ADDENDUM NUMBER 2 – JULY 22, 2024

AUGUSTA REGIONAL LANDFILL – LFGCCS EXPANSION

SOLID WASTE PERMIT NO. 21 AND NO. 585

Prospective Bidders are hereby advised of the following revisions to the Bid Documents for the subject Project:

CADD FILE:
02208015.37

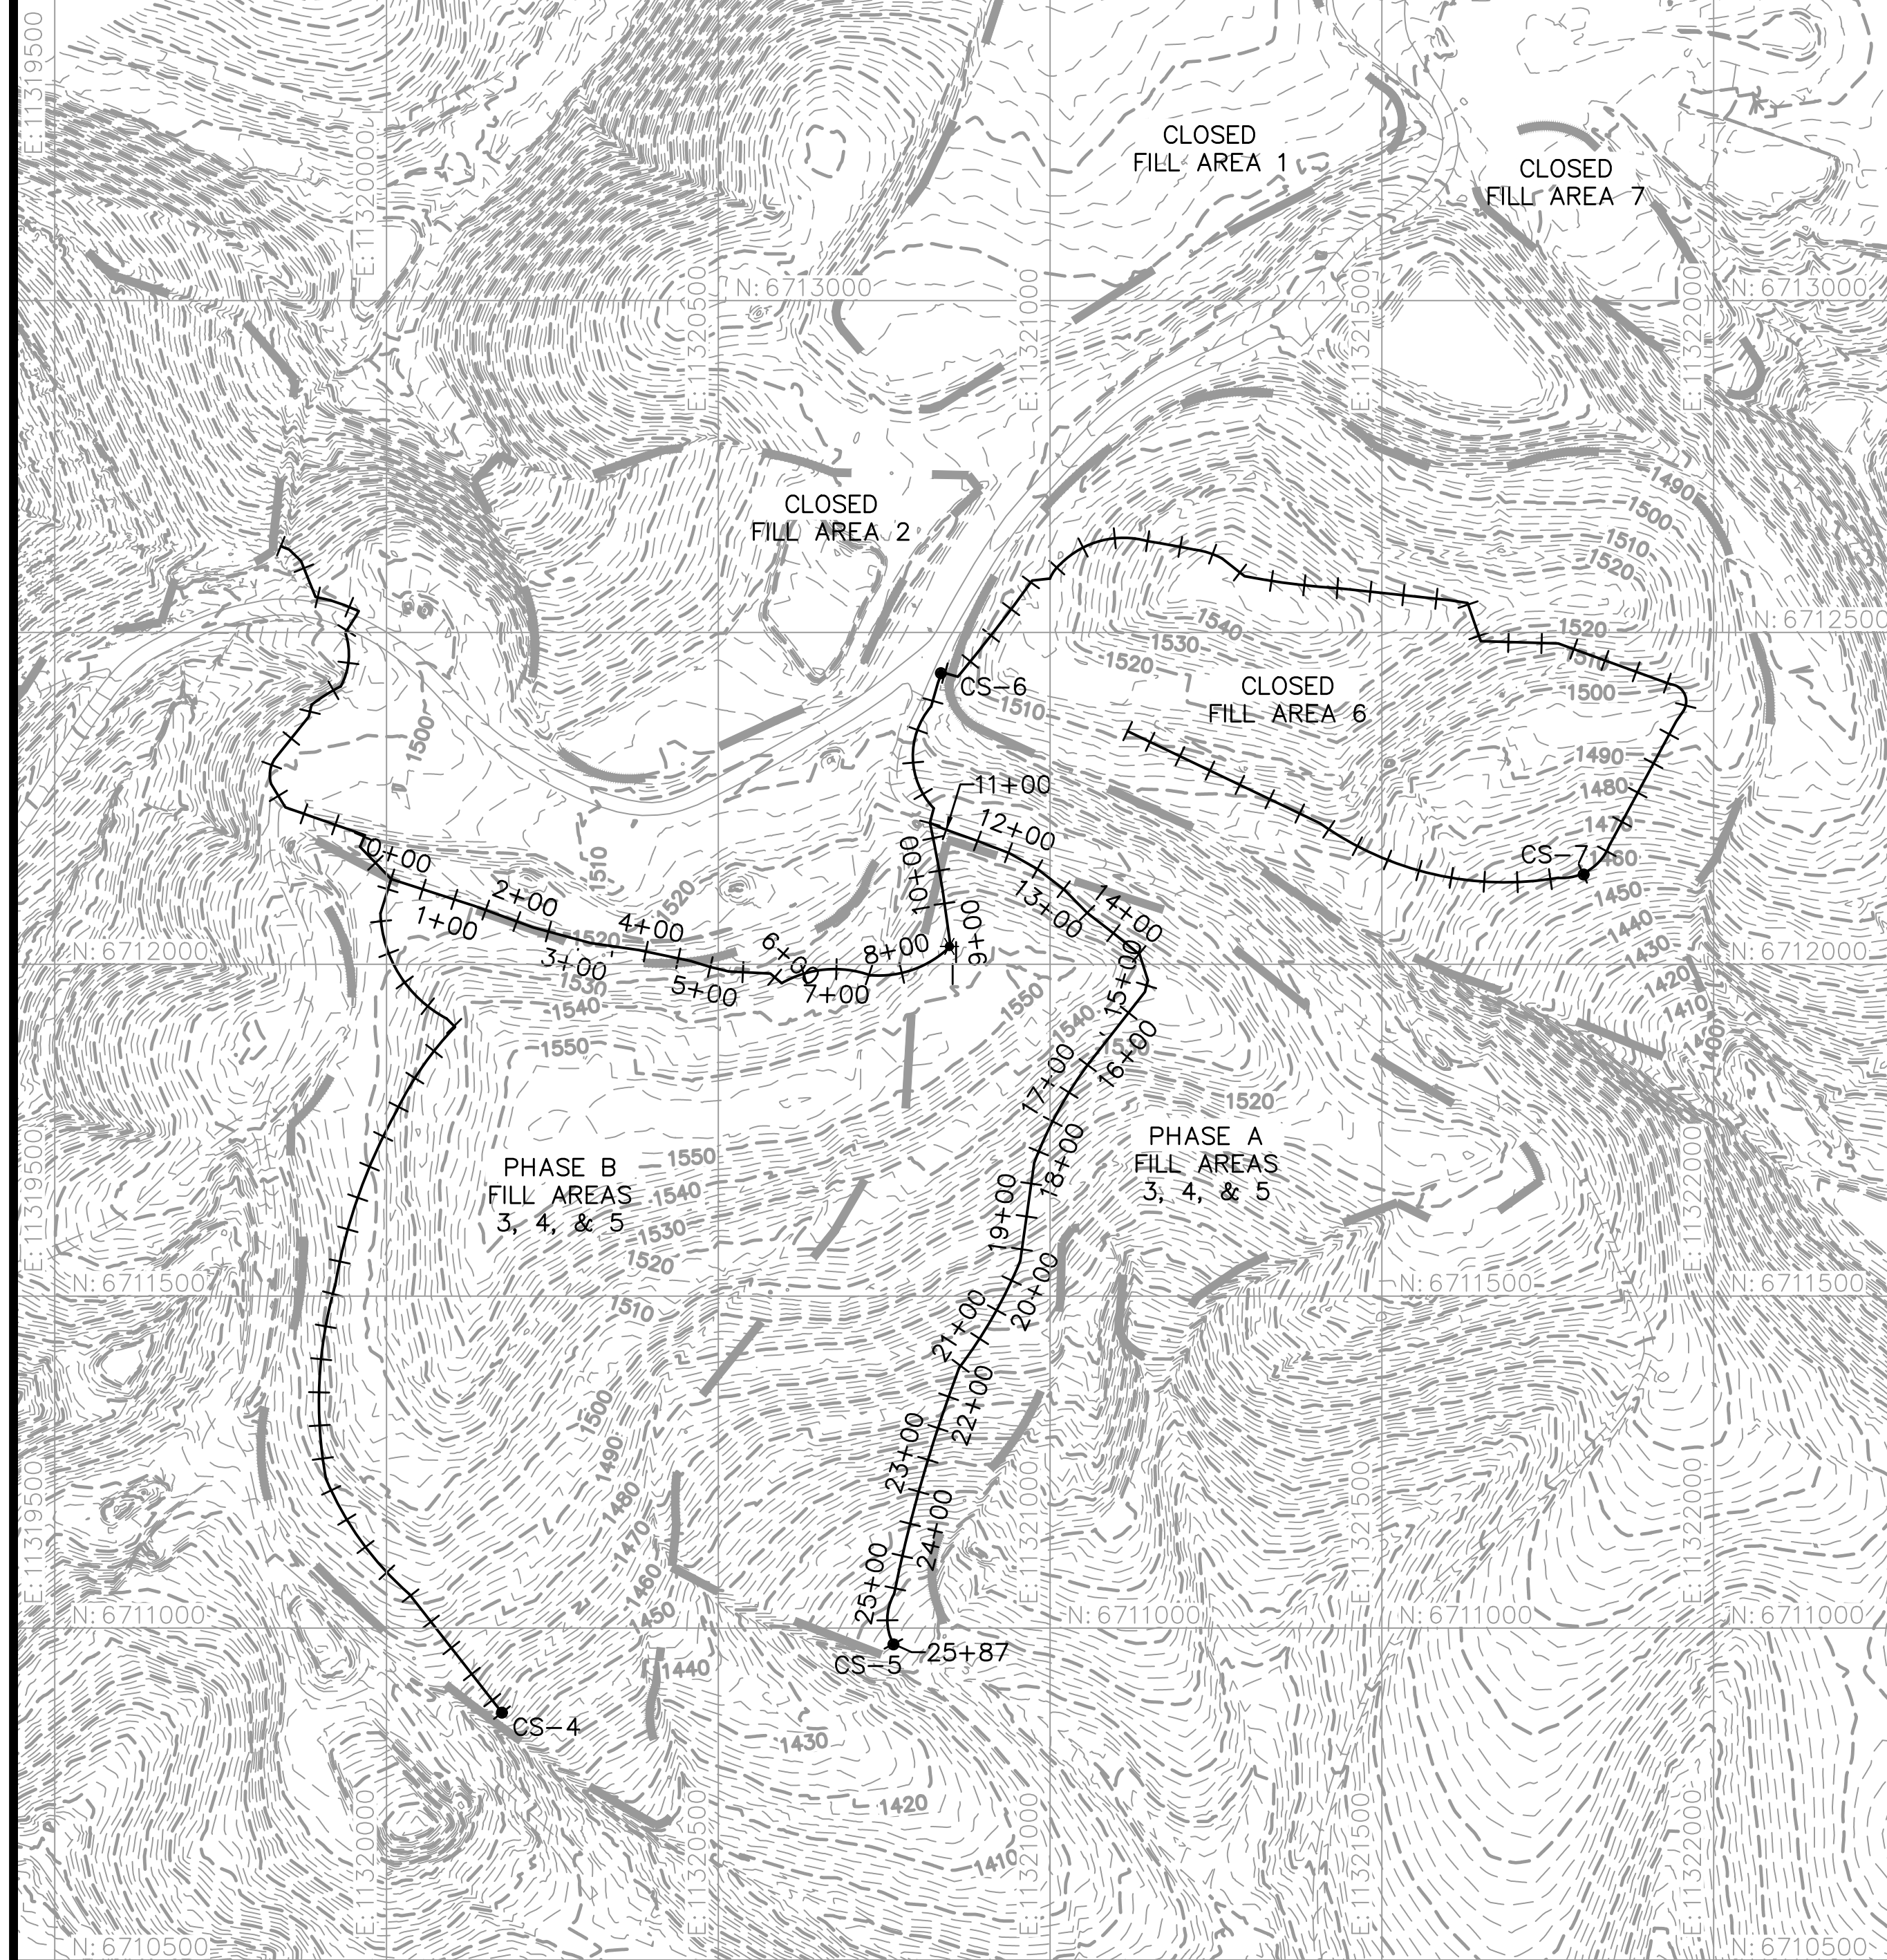
- Profiles on Sheet No. 7A, Sheet No. 7B, and Sheet No. 7C have been revised to reflect a minimum pipe depth of 3 feet. Additional notes have also been added to these sheet.

BURIED LFG COLLECTION PIPE IN COMMON TRENCH WITH AIR AND FORCEMAIN DETAIL
N.T.S. 1/9 6A 9

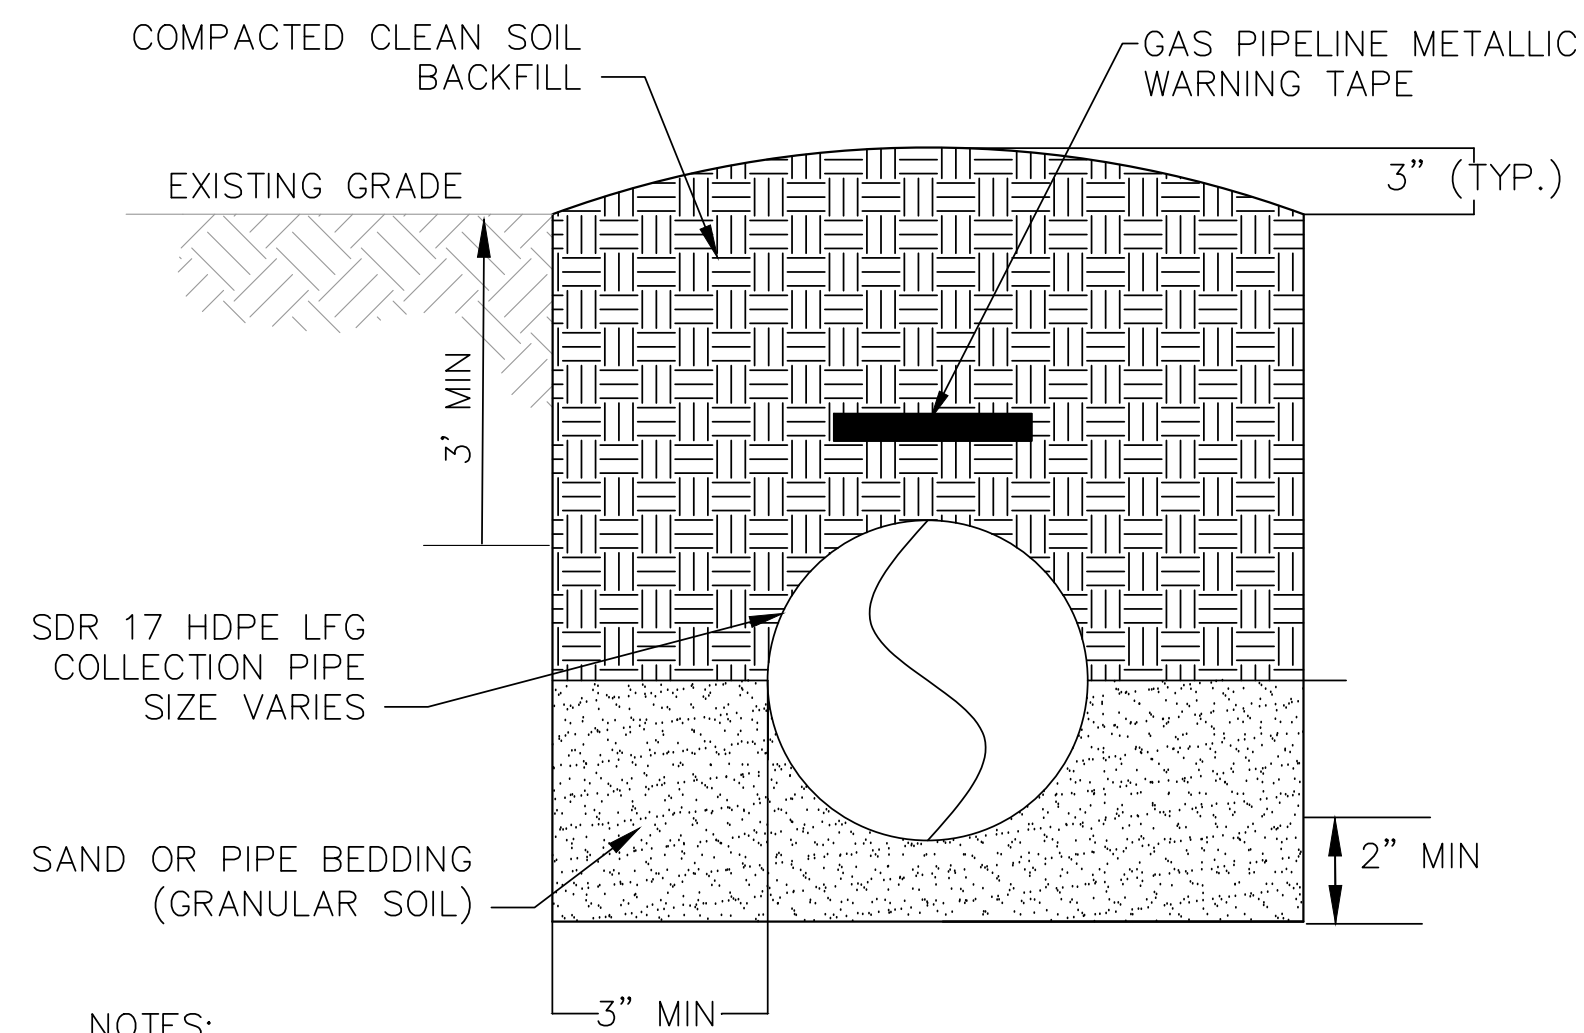
Question 7: Detail 1 on Sheet No. 9 references Sheet No. 6A, but there was not a call-out for Detail 1 Sheet No. 9 on Sheet No. 6A. What is this detail referring to?

Answer: Detail 1 on Sheet No. 9 is the typical detail for the installation of Landfill Gas Collection piping in a common trench with airline and liquids forcemain. The detail should be used when landfill gas collection piping, airline, and liquids forcemain are shown running parallel to one another (i.e. in a common trench). Bidders should be familiar with this type of installation. A callout has been added to Sheet 6A for clarity.

SOIL CAP DETAIL
NOT TO SCALE

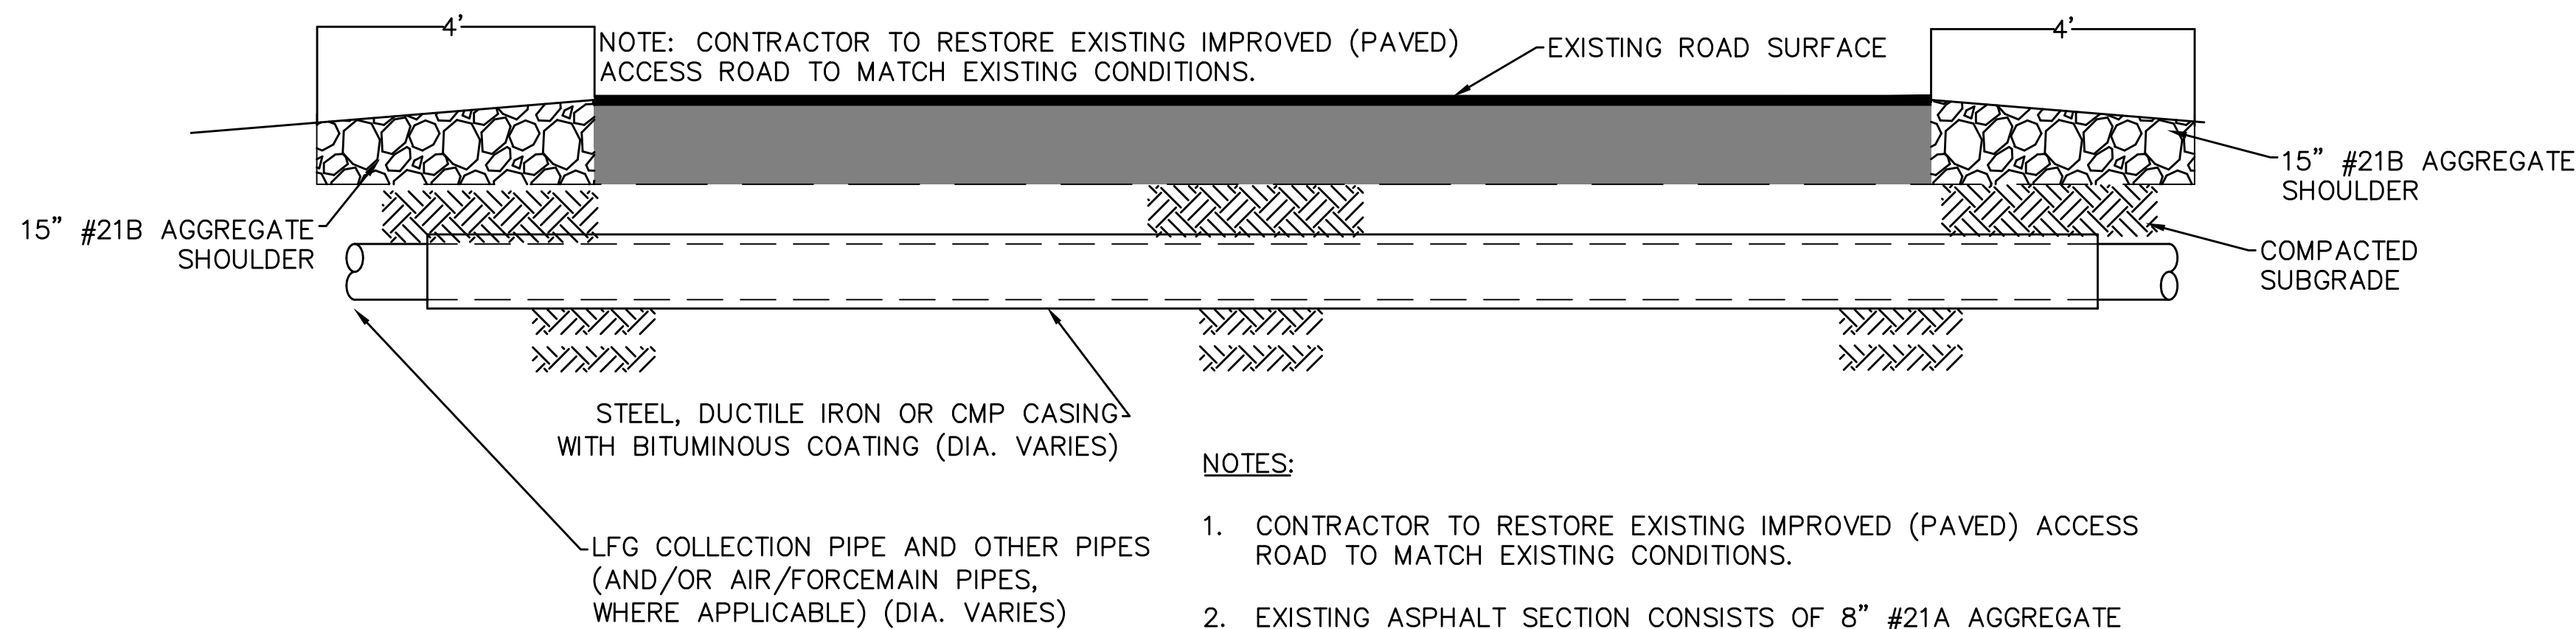
- Descriptions of soil layers in Detail No. 1 on Sheet No. 11 have been revised.
 - Detail No. 1 has been added to new Sheet No. 12 to incorporate a gravity drain connection to existing manhole detail.

Question 13: Detail 1 Note 3 on Sheet No. 11 refers to infiltration layer soil. What does infiltration layer soil refer to?

Answer: Infiltration layer soil refers to the compacted soil cap layer as shown in the Detail. Both of these labels may be used interchangeably throughout the drawings and specifications.

TYPICAL GRAVITY DRAIN CONNECTION TO STANDARD PRECAST MANHOLE
 N.T.S. 1
6A12

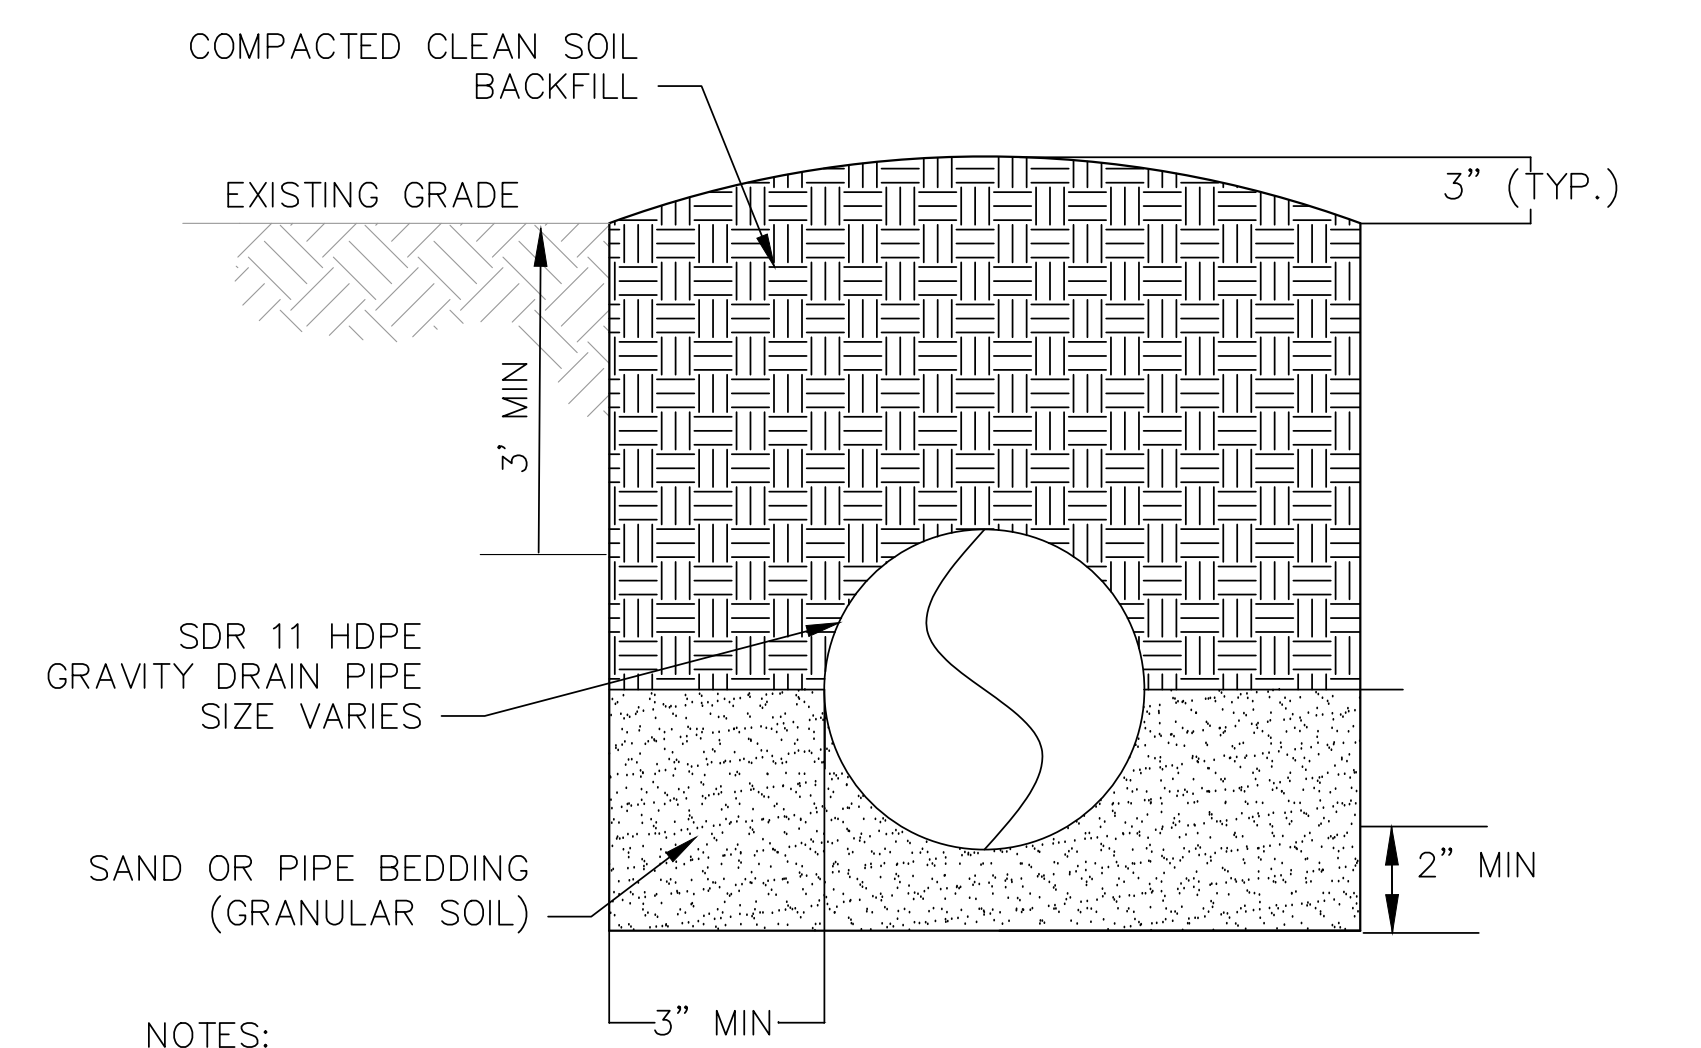
Question 6: *Can a detail be provided for the connections to each of the existing manholes/vaults?*

Answer: A typical detail for connection to the existing manholes/vaults has been added to the drawings. The new detail is Detail 1 on Sheet No. 12.

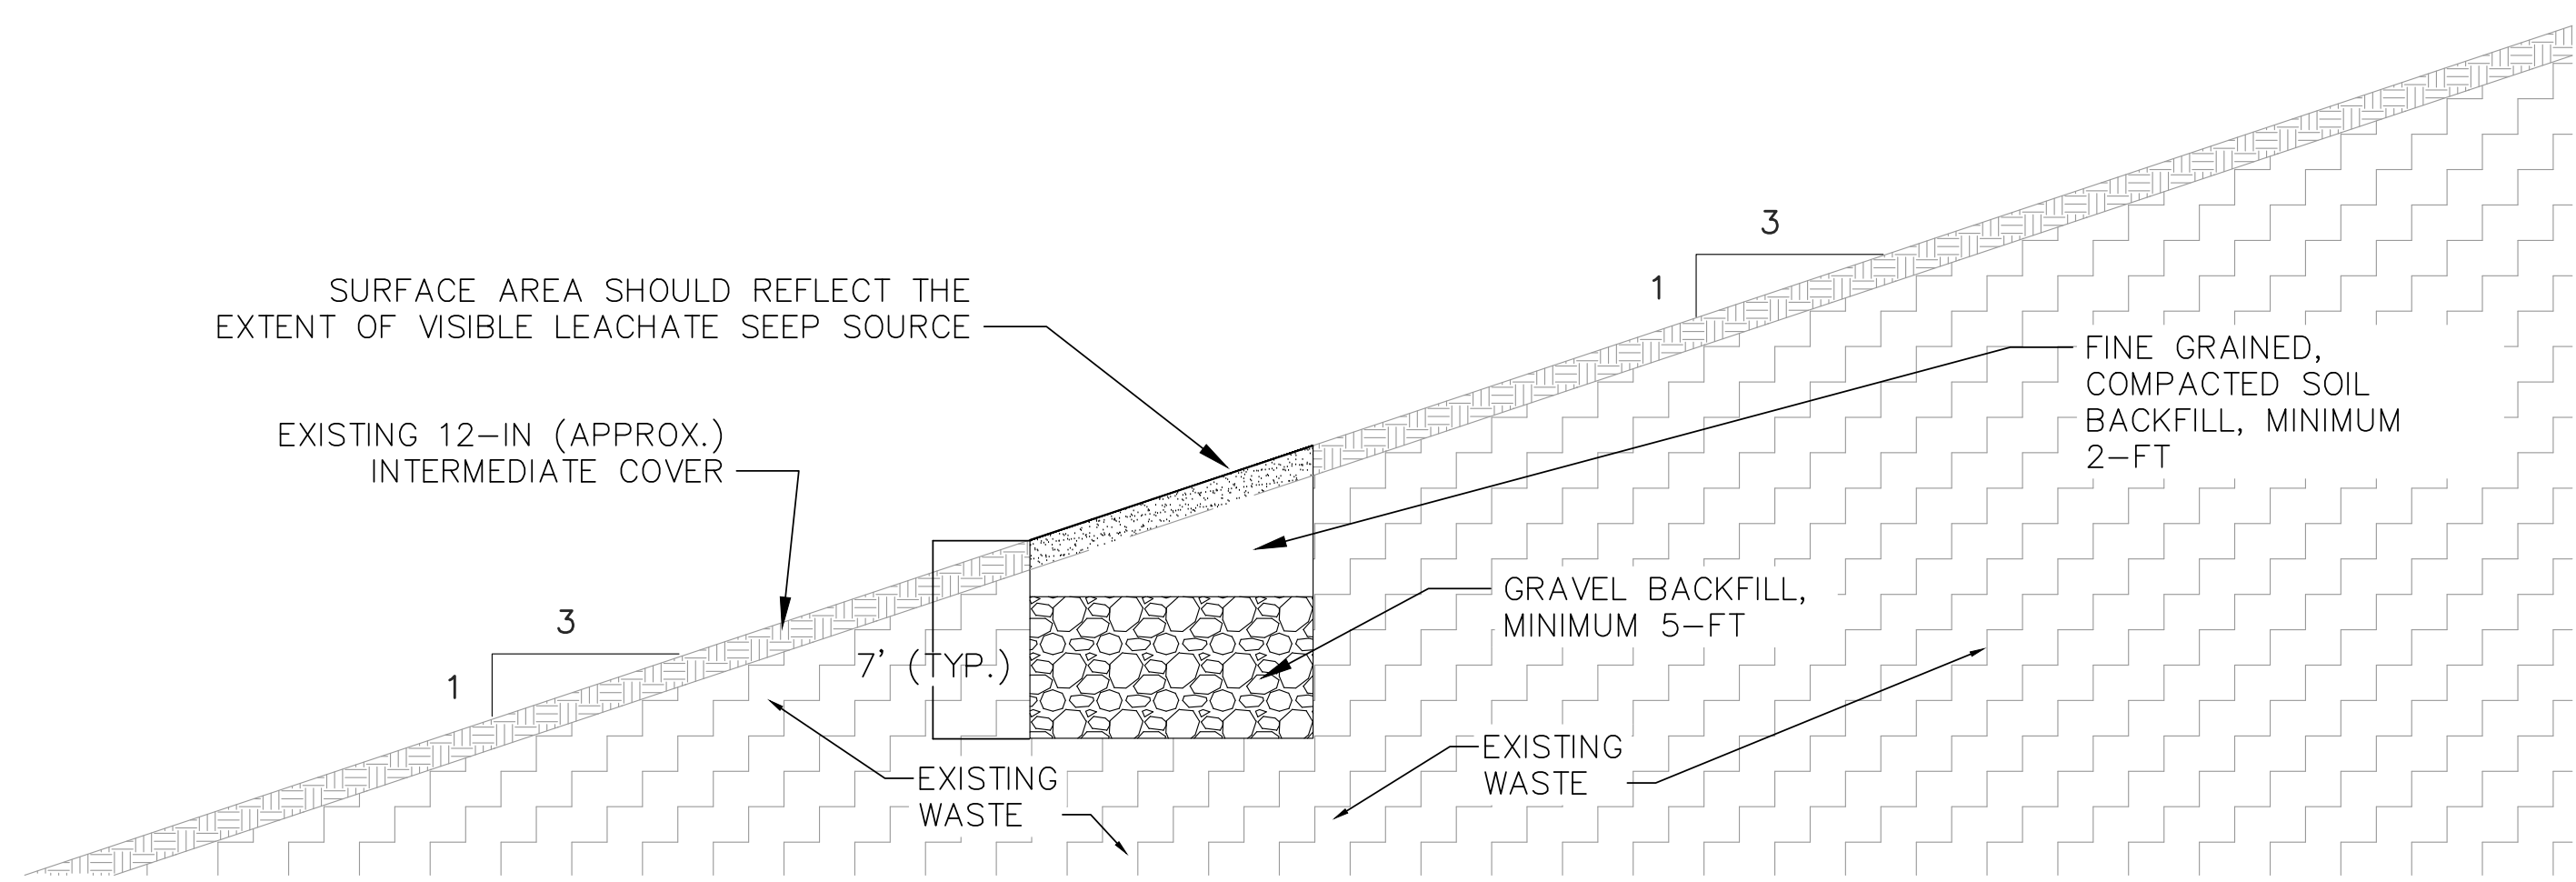
- Detail No. 2 has been added to new Sheet No. 12 to incorporate a gravity drain detail.
 - Detail No. 3 has been added to new Sheet No. 12 to incorporate a leachate seep repair detail.

Question 5: *Is the contractor to install a 4" Gravity Line from CS-4, CS-5, and CS-7 to the existing manhole vaults shown? Can a detail for these lines be provided?*

Answer: Yes. Detail 2 on Sheet No. 12 has been added for the installation of the 4-inch gravity line.
